SERVICE INSTRUCTION

RUNNING MODIFICATIONS ON

ROTAX® ENGINE TYPE 912/914 (SERIES)

SI-912-020R9

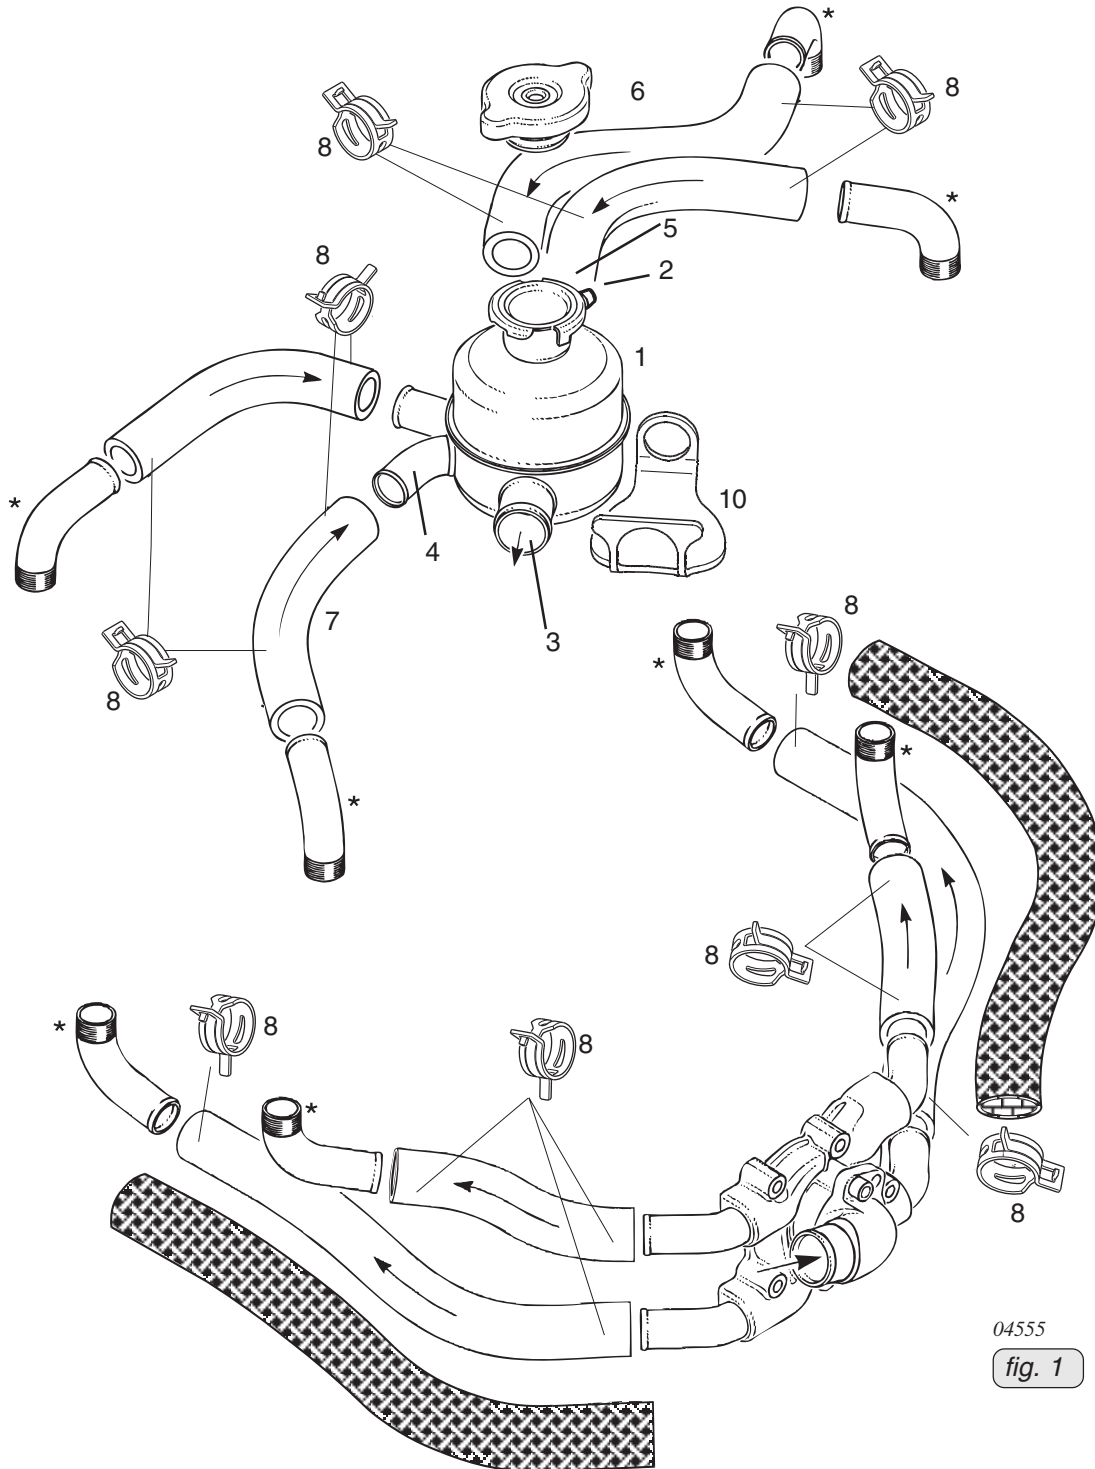
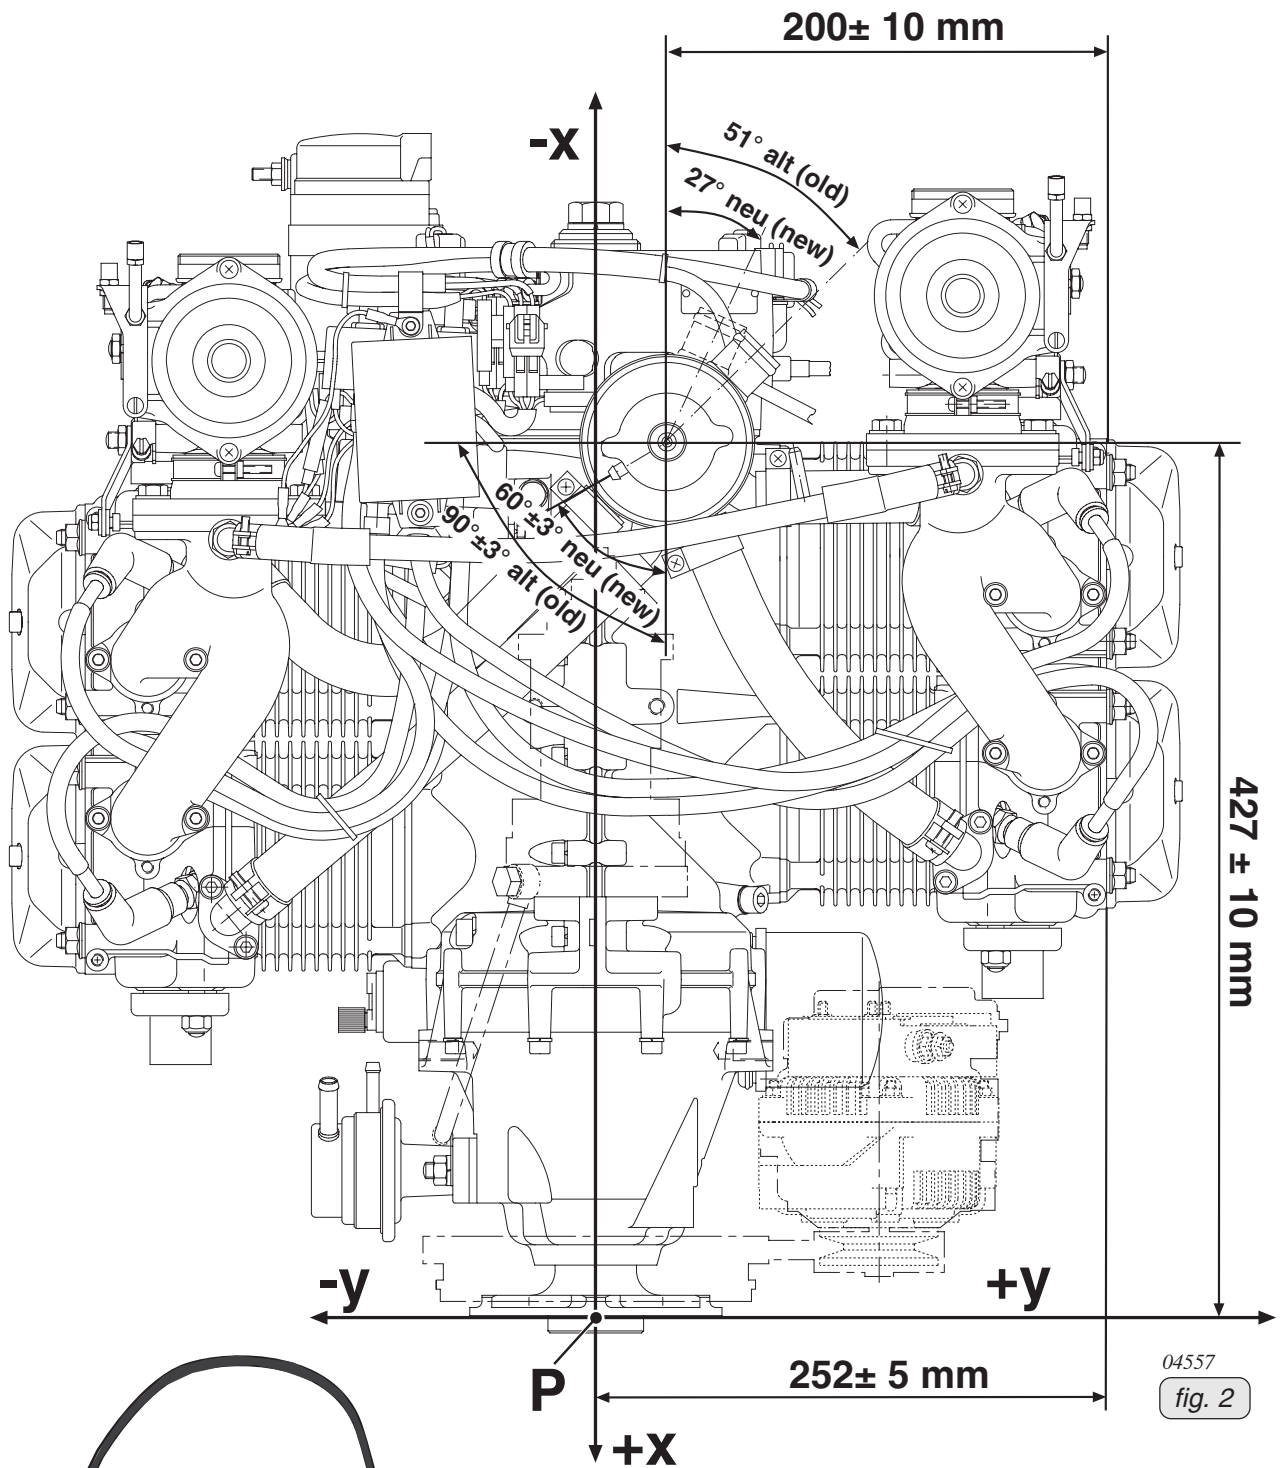
In the course of further development and standardization the position of the expansion tank (1) has been optimized!

- position of connection (2) to overflow bottle (from 0° to 30±3°)
- position of connection (3) to radiator (from 51° to 27±3°)
- angle of inlet socket (4) from cylinder 4 (34° inclined)
- length of inlet socket (5) from cylinder 3 (length increased by 13,4±3 mm)
- length of coolant hose (6) from cylinder 1 (length increased from 270 mm to 285 mm)
- length of coolant hose (7) from cylinder 4 (shortened from 100 mm to 85 mm)
- new spring type hose clamps (8) to attach the coolant hoses (expansion tank and water pump)

- Install the coolant hose (6) 285 mm to cylinder 1 and the new coolant hose (7) 85 mm to cylinder 4. For attaching all the coolant hoses from expansion tank, water pump, cylinders, use the new spring type clamps.

■ **CAUTION:** Take care of appropriate slip-on length of the coolant hoses on the corresponding connection socket. Verify tight fit of clamps and hoses and check for leakage. Always fit the clamps such that they can not wear on any component and use a suitable tool (see fig. 3) for fitting them.

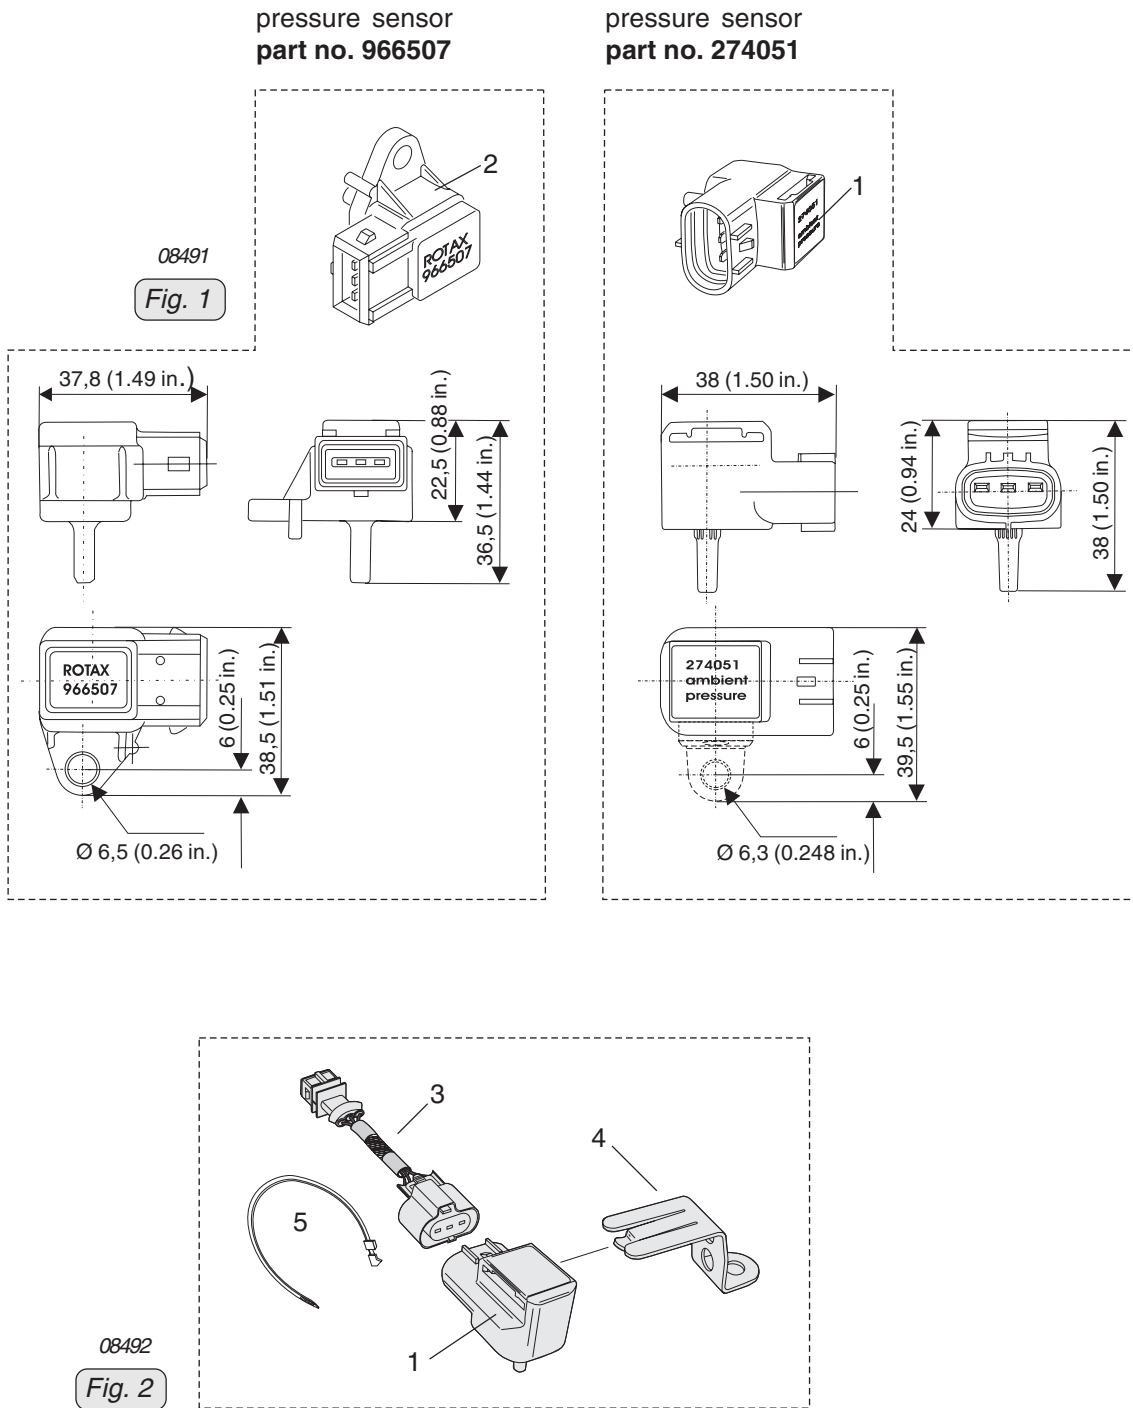
Due to the termination of production of the ambient pressure sensor (part no. 966507) a new ambient pressure sensor part no. 274051 has been introduced. The new ambient pressure sensor is of different size and also has a different connector. The connection for the wiring harness had to be changed.

1. Disconnect the pressure sensor (2) from the wiring harness.
2. Connect adapter cable (3) to wiring harness and to the new pressure sensor (1).
3. Install bracket (4) onto pressure sensor.

■ CAUTION: Route all wiring as such that there will be no sharp bends or chafing.
4. Position adapter cable and secure with cable binders (5).

new Version

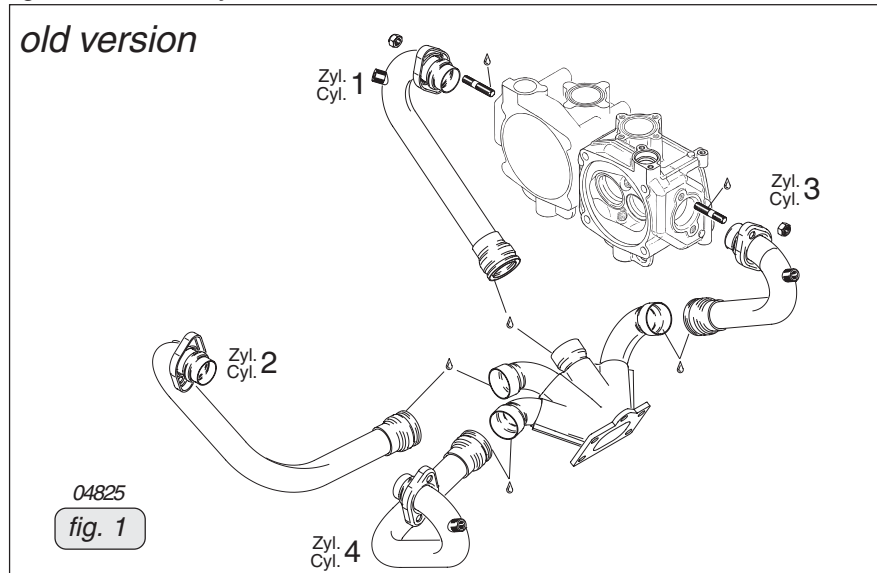
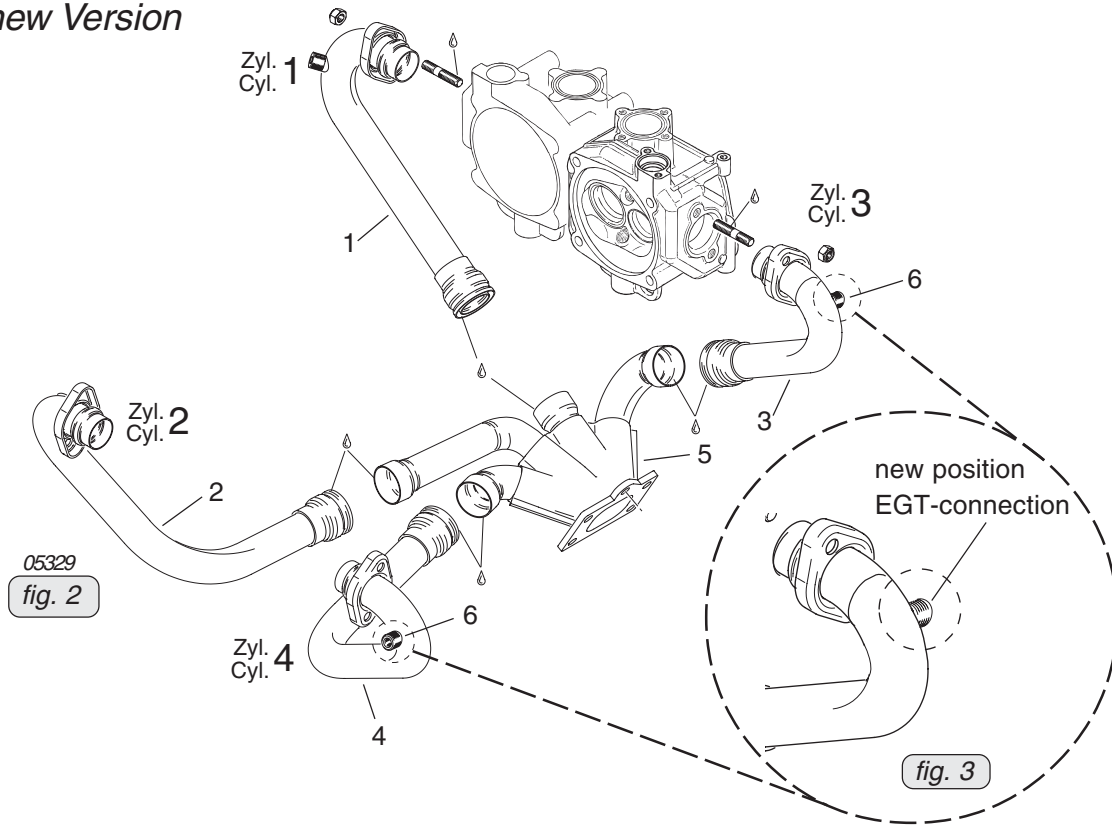
Owing to continuous further development, the exhaust bends were slightly re-worked. The couplings were optimized for their position.

- Position of the EGT connections (6) to the exhaust bends for cylinders 3 and 4 were routed such that installation of the new drip trays is possible.

◆ NOTE: If replacement of any single old part number is necessary, you must replace it with the same old part number. If the old part number is not available, the **entire** assembly including all 4 pipes and manifold must be replaced with new part numbers. New style pipes and manifold are not interchangeable with old style.
